PLAN OF PROPOSED IMPROVEMENT

BIRCHWOOD POINT SOUTH

STORMWATER MANAGEMENT

CITY PROJECT NO. 11933 CITY CONTRACT NO. 8196 MUNIS NO. 11933

DATE: 08/04/20
 REVISED:
 DRAWN BY: GVP
 FN: 18-04-105
 Sheet Number:
 7

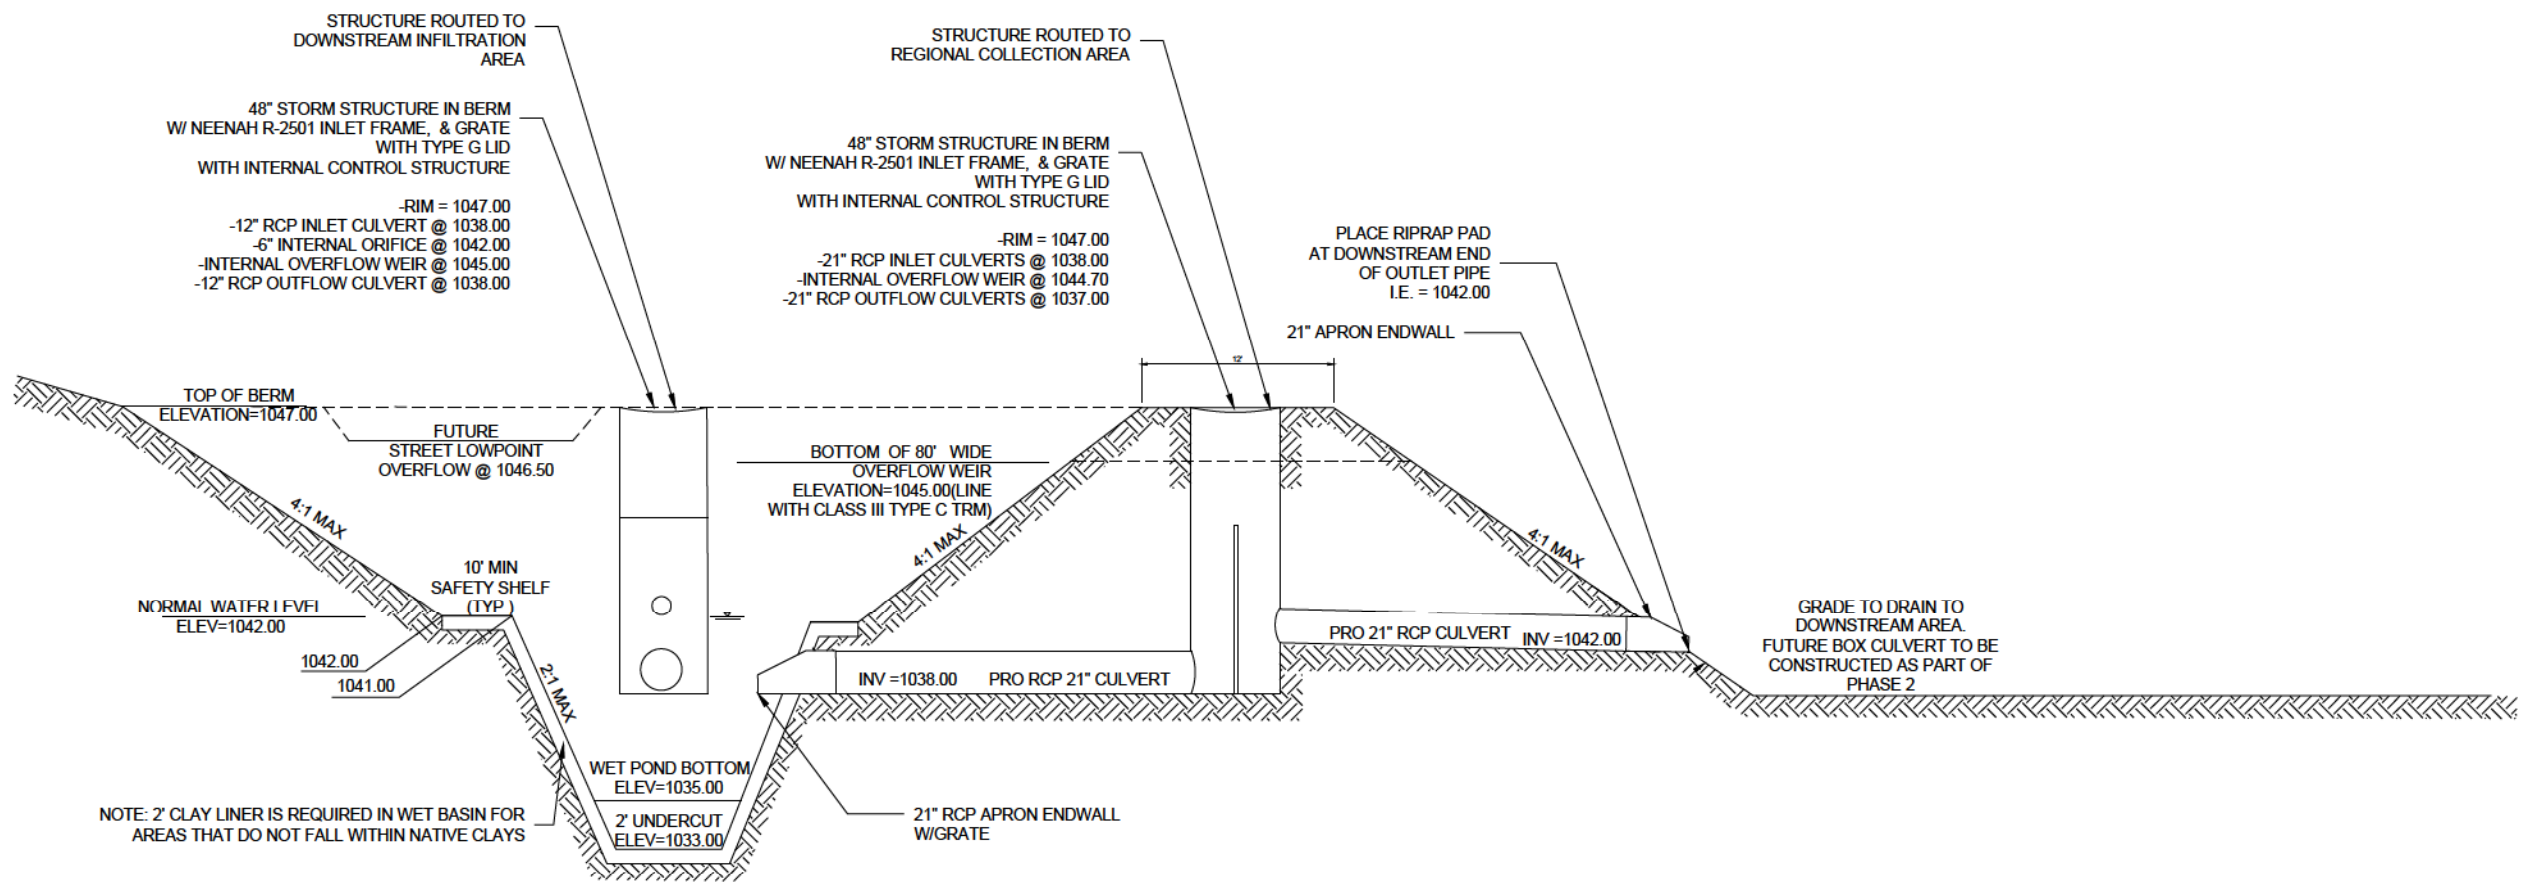
REV 2021 06-30 JPS
 PREVIOUSLY BUILT CHANNEL AND PREVIOUSLY DESIGNED CHANNEL HAS BEEN UPDATED WITH WESTERN ADDITION 1000 OAKS PHASE 2 WORK. SEE 12629 FOR UTILITY AND STREET DESIGN SEE SHEET 9 THIS PLAN SET FOR GRADING DESIGN

PHASE 2 STORMWATER MANAGEMENT DETAIL

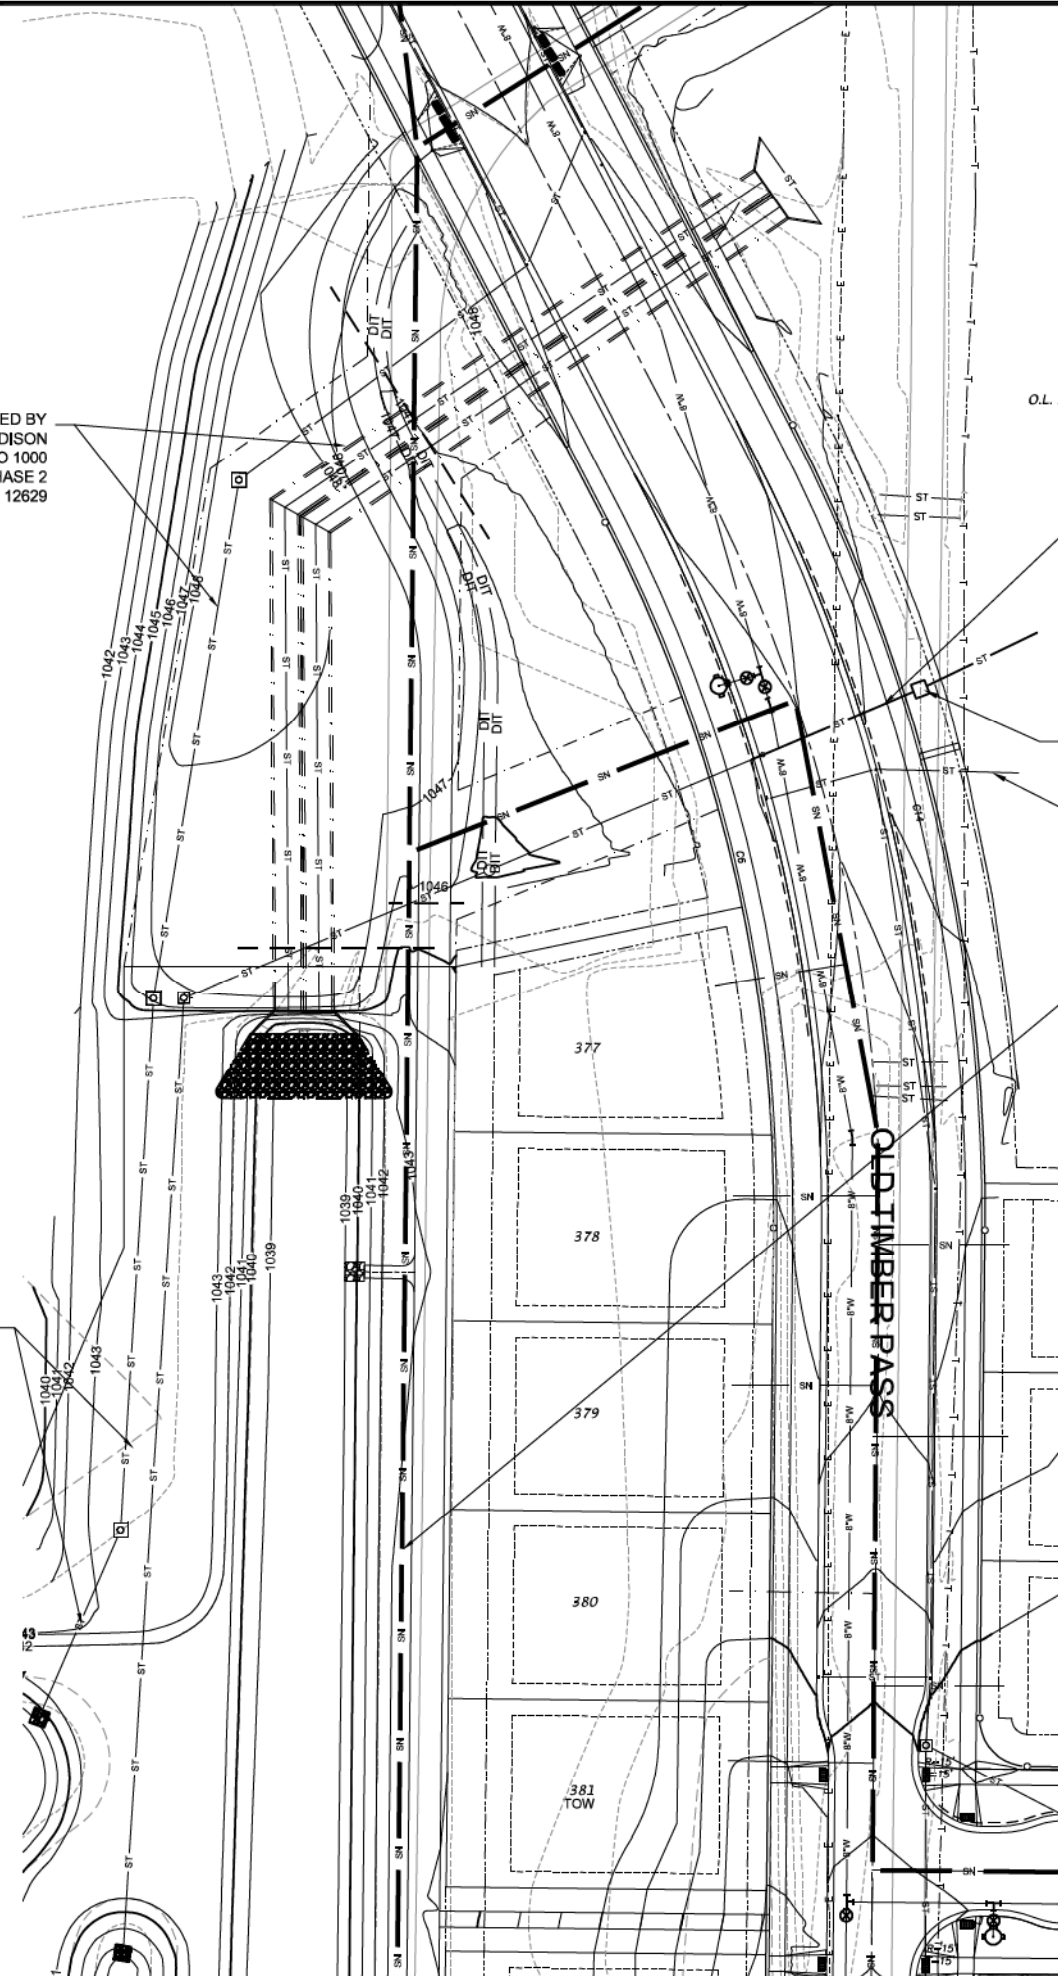
REV 2021 06-30 JPS
REVIOUSLY BUILT CHANNEL AND PREVIOUSLY DESIGNED STORM SEWER HAS BEEN UPDATED WITH WESTERN ADDITION 1000 OAKS PHASE 2 WORK.
SEE 12629 FOR UTILITY AND STREET DESIGN
SEE THIS SHEET FOR GRADING DESIGN

11933
 PBM-1

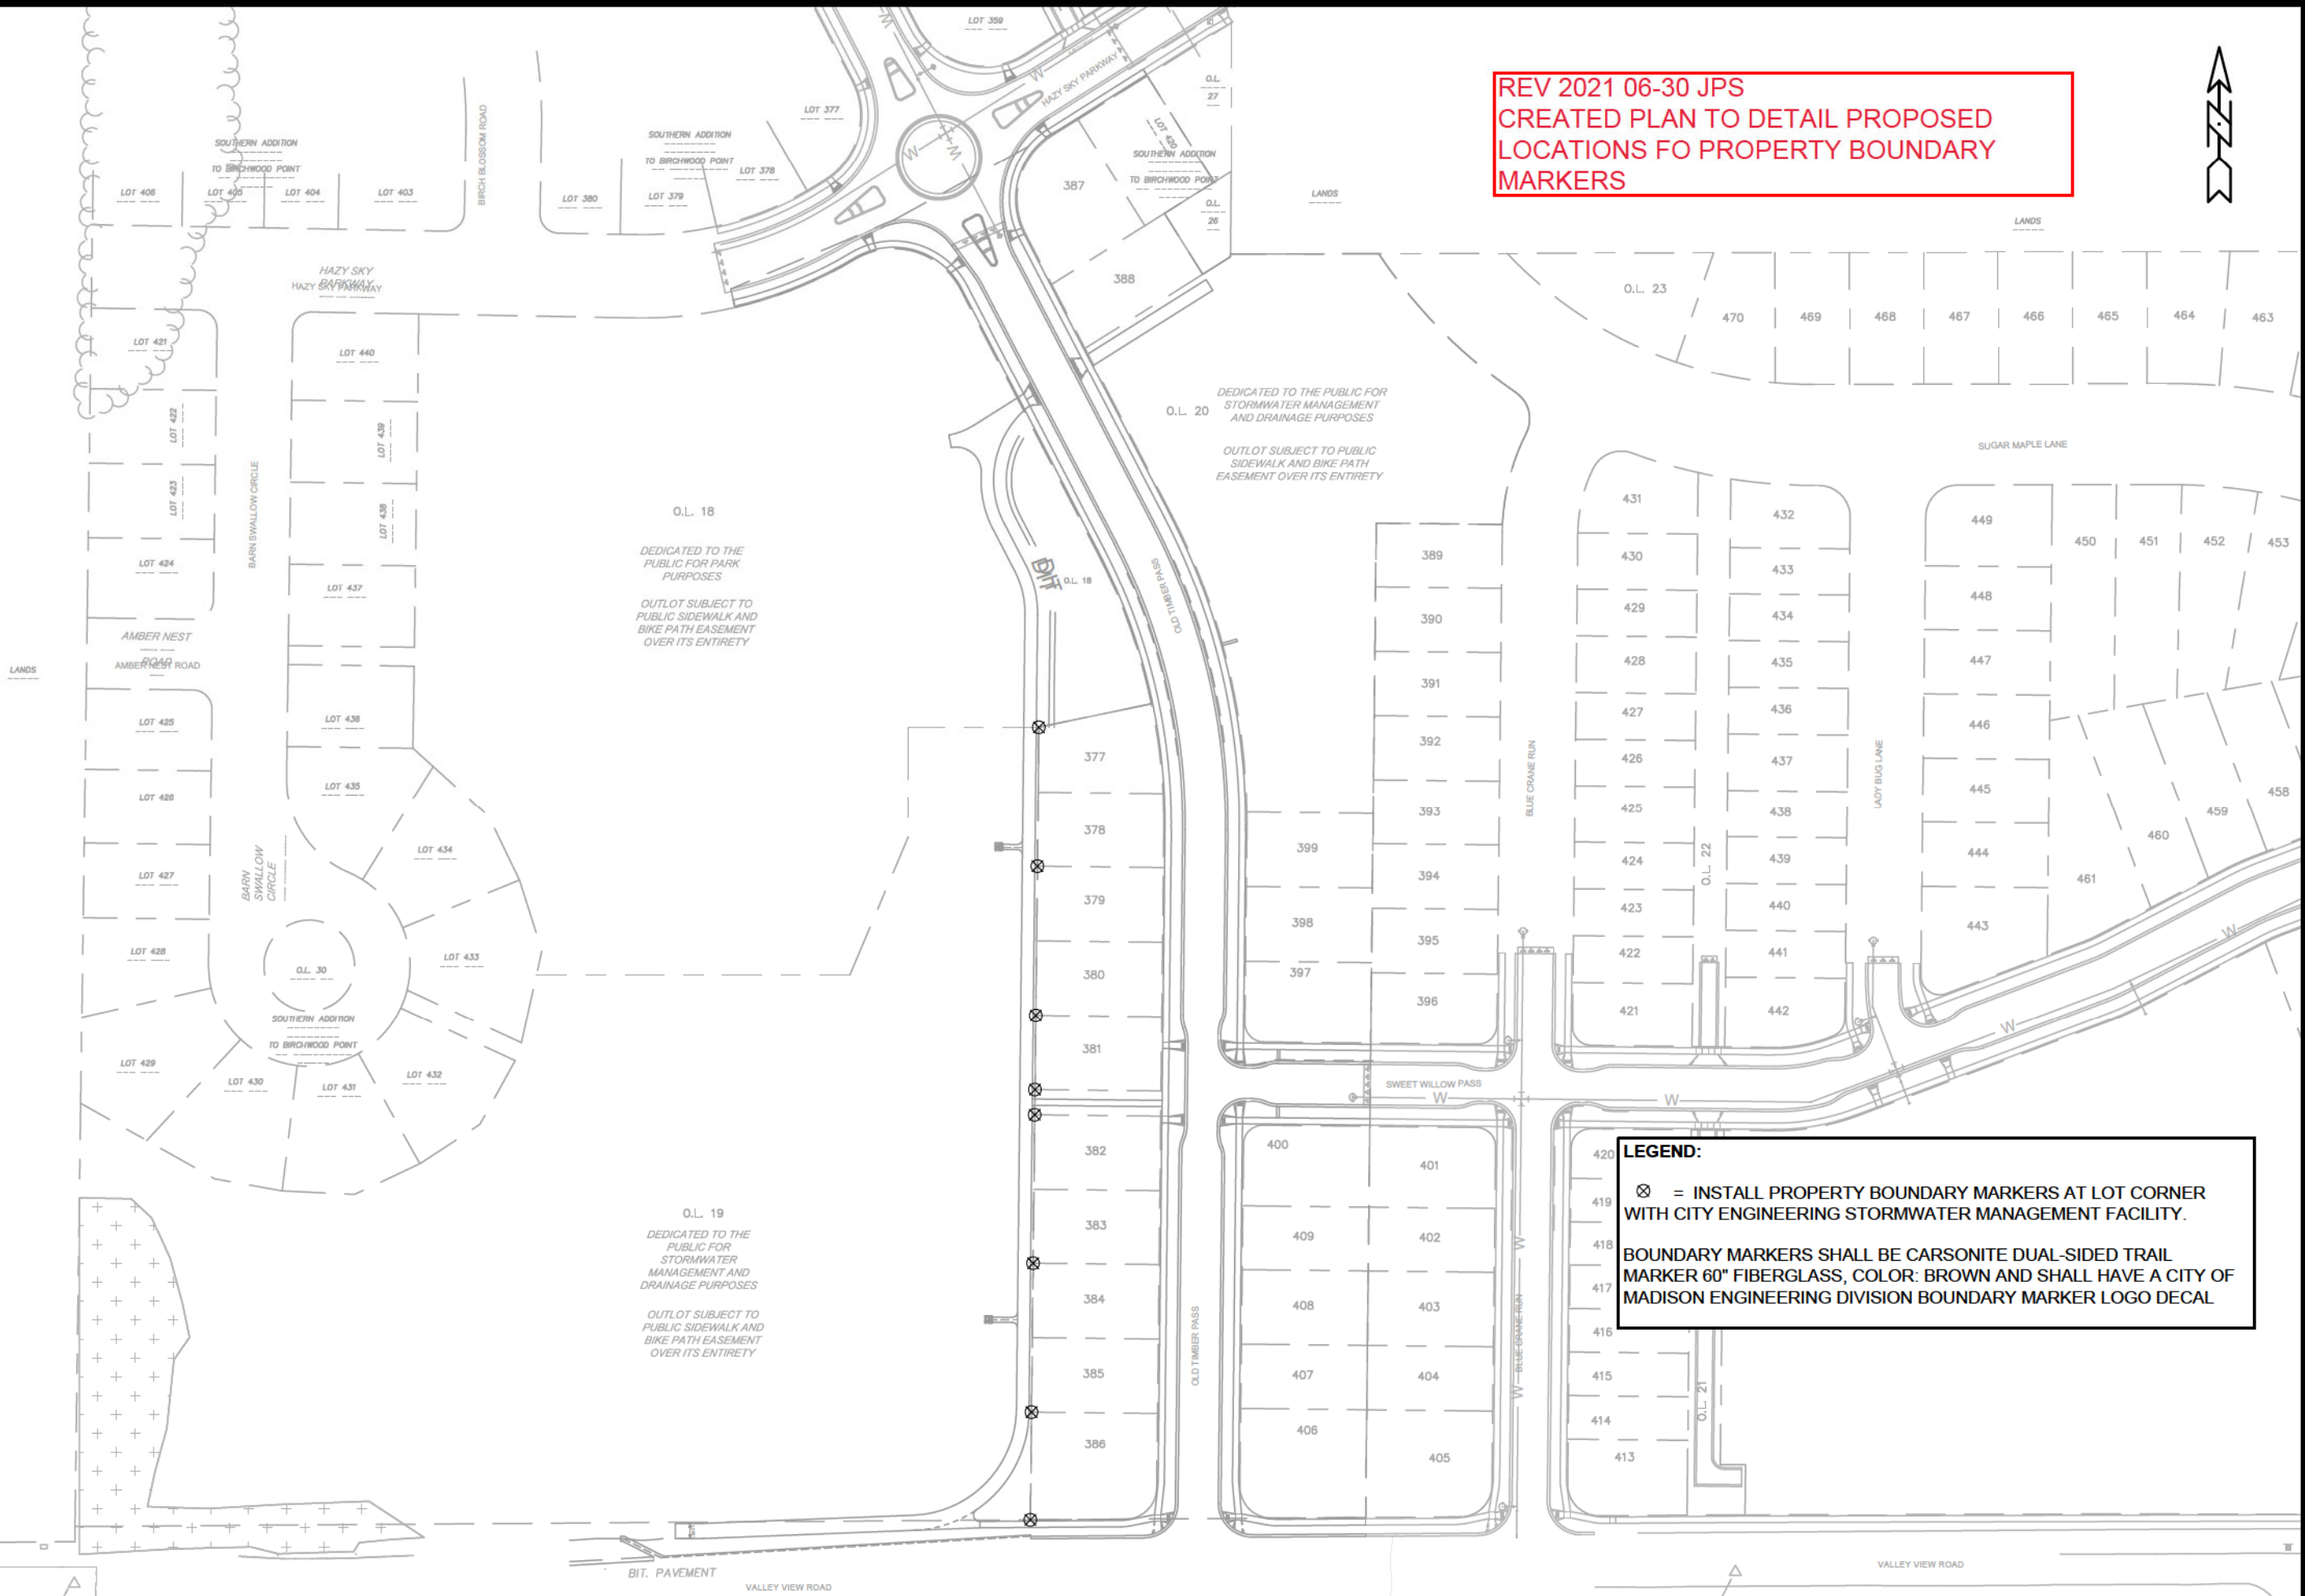
REV 2021 06-30 JPS
 CREATED PLAN TO DETAIL PROPOSED
 LOCATIONS FO PROPERTY BOUNDARY
 MARKERS

LEGEND:
 ⊗ = INSTALL PROPERTY BOUNDARY MARKERS AT LOT CORNER WITH CITY ENGINEERING STORMWATER MANAGEMENT FACILITY.
 BOUNDARY MARKERS SHALL BE CARSONITE DUAL-SIDED TRAIL MARKER 60" FIBERGLASS, COLOR: BROWN AND SHALL HAVE A CITY OF MADISON ENGINEERING DIVISION BOUNDARY MARKER LOGO DECAL
